**Response to Comments
on
EPA Draft 2020 Permit Modification to the 2016 Reissued RCRA Permit and
Associated Statement of Basis for EPA’s Remedial Action for the “Rest of River”
Portion of the Housatonic River**

GE-Pittsfield/Housatonic River Site

December 2020

U.S. Environmental Protection Agency
Region 1 (EPA New England)

**FIGURE 10
SURFACE WATER PROTECTION AREA
ZONE A AND WATERSHED SUBBASINS**

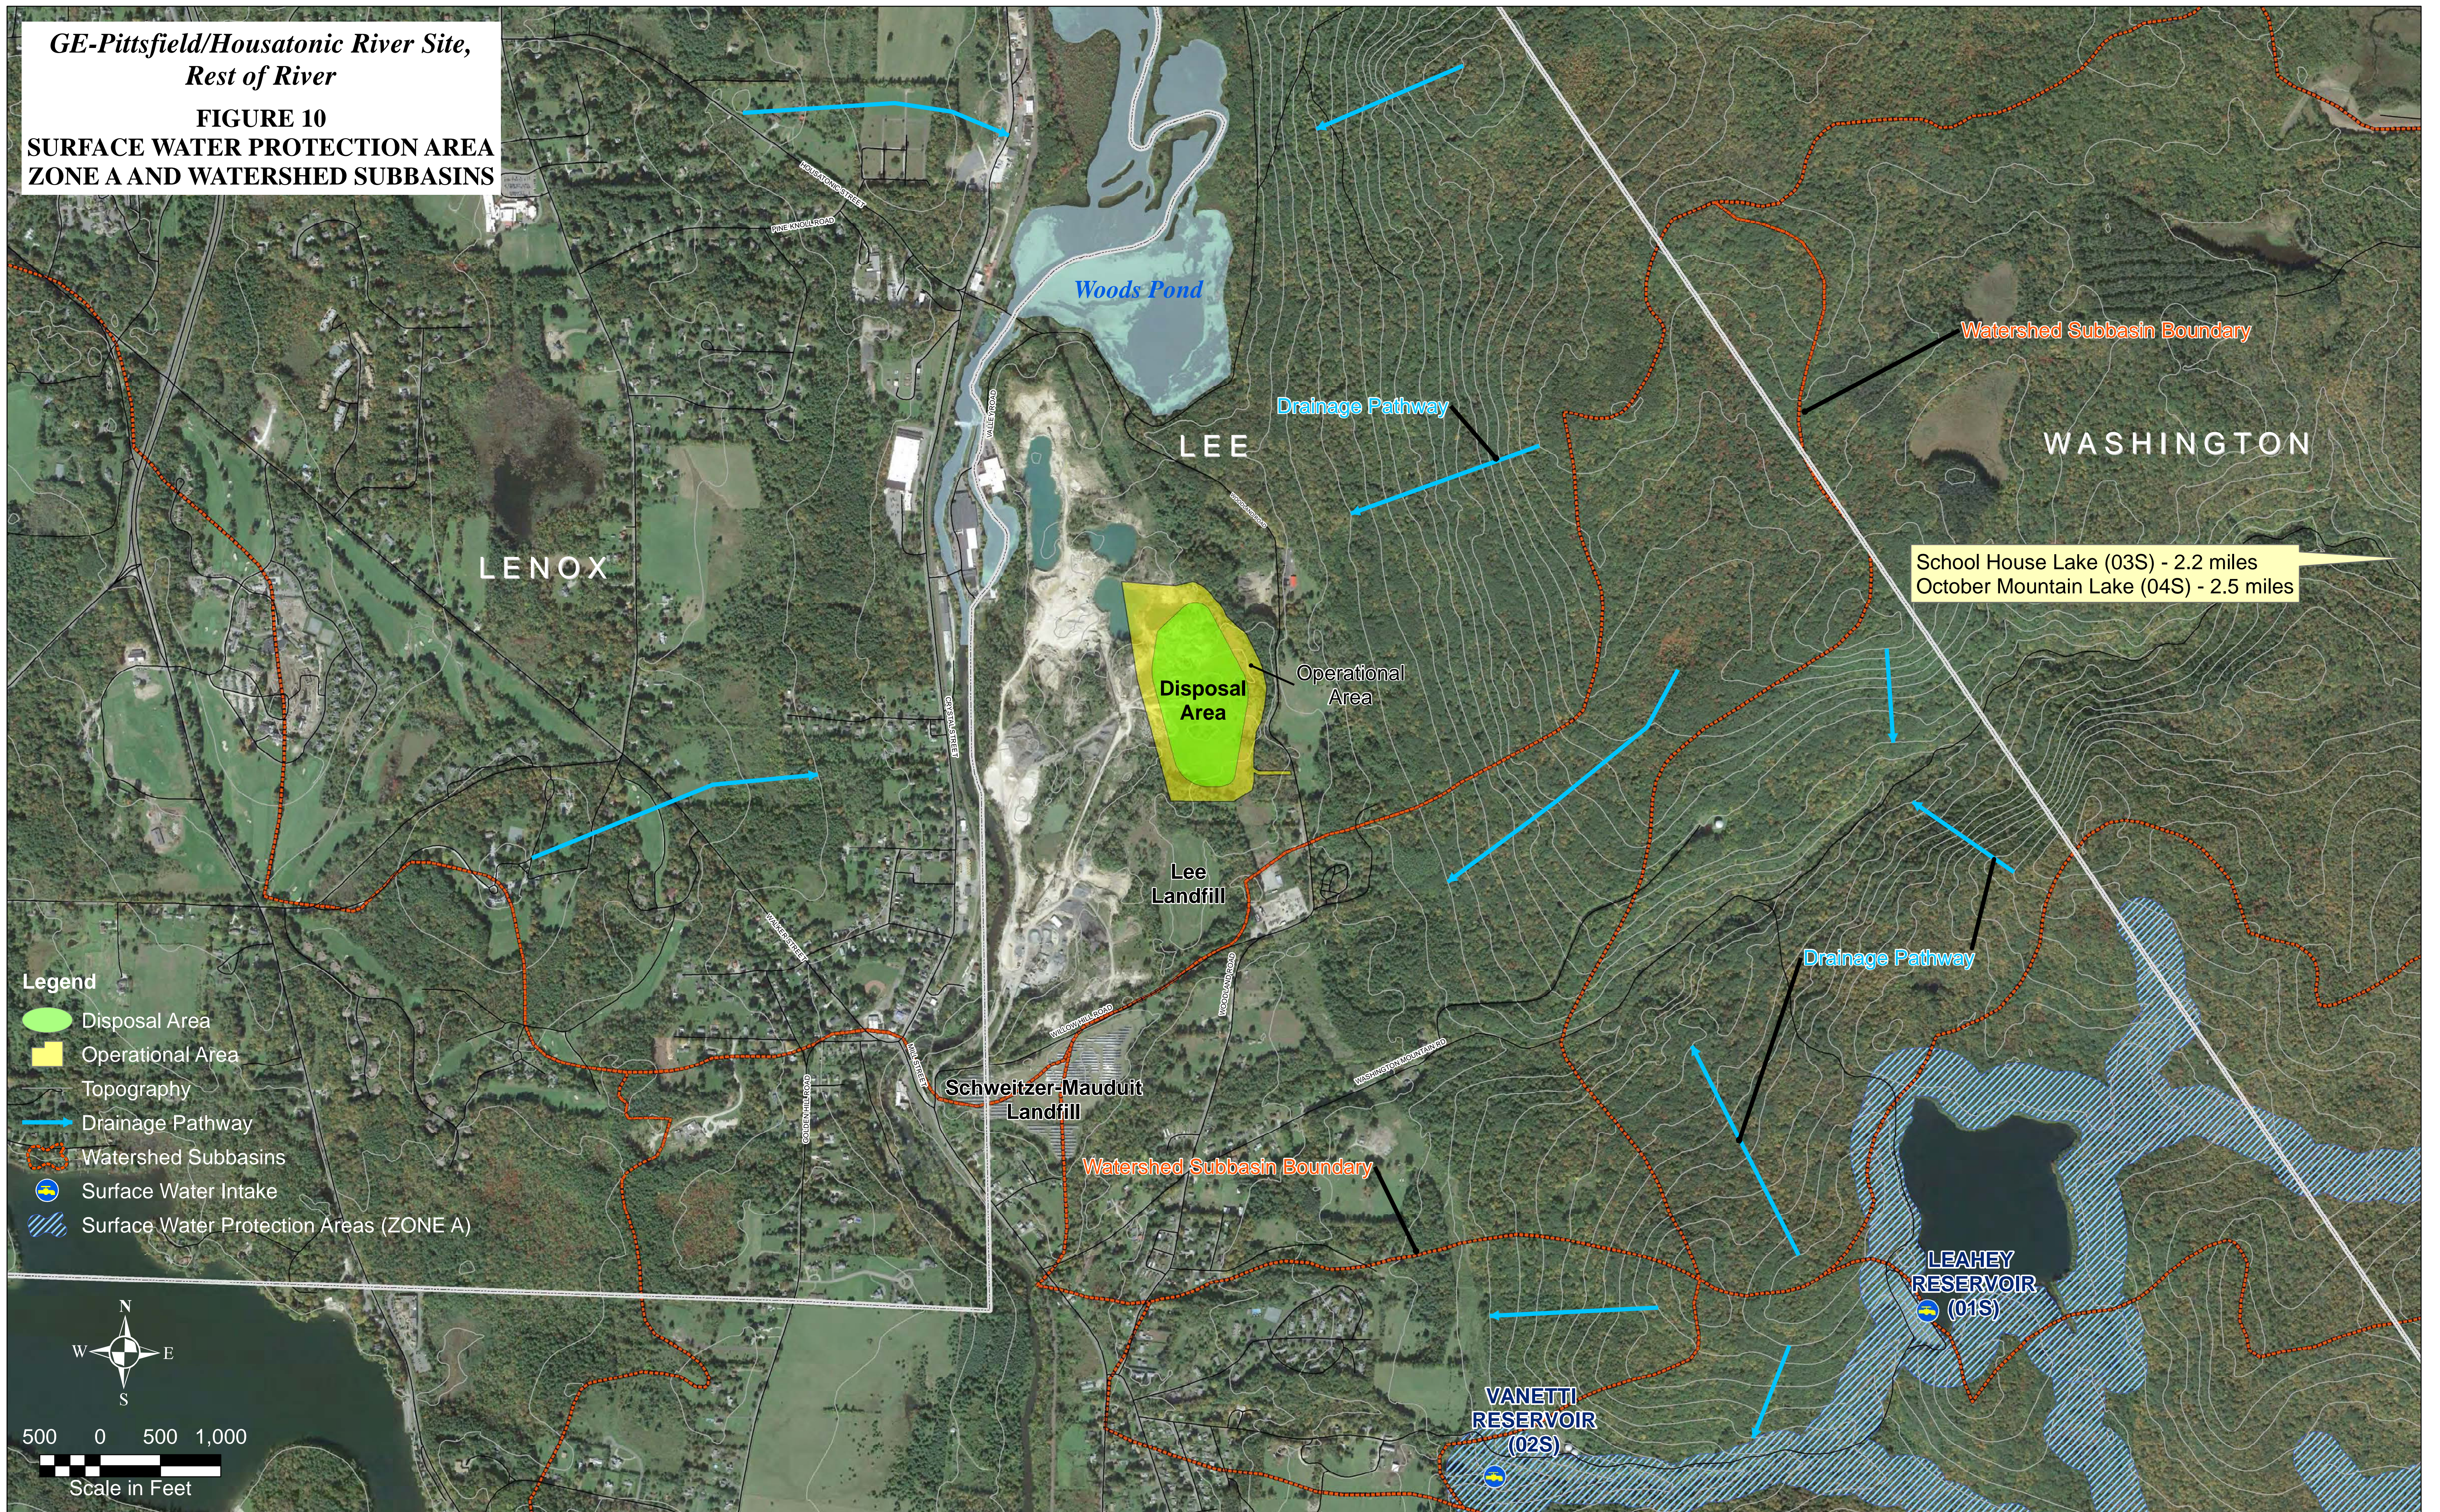
Comment II.A.5: Several commenters expressed concerns about impacts to local water supplies should a release occur. A number of commenters questioned the provisions for abandonment of

In addition, as shown on Figures 10 and 11, the topographic contour lines and approximate surface water body elevations show that the surface waters that are part of the Lee water supply system are at a much higher elevation than the proposed UDF. The current high point in the area of the proposed UDF is at an elevation of approximately 1,050 feet above mean sea level (AMSL). The bottom liner of the UDF will be at an elevation of approximately 965 feet AMSL. The Housatonic River in the area of the directly west of the UDF is 935 feet AMSL, whereas the Town of Lee’s reservoirs are at approximate elevations of 1,129 and 1,597 feet AMSL. Figure 7. This is further confirmation, combined with the information on the watershed drainage subbasins, that surface water runoff from the area of the UDF would be away from the Lee reservoirs and towards the River. That is, to theoretically reach the Lee water supplies, stormwater surface runoff would have to run off the UDF, uphill from the base of the UDF, down into one basin, back uphill, down into another basin, and then steeply uphill again to the surface water intake of the Leahey Reservoir (the Vanetti reservoir is an emergency reservoir).
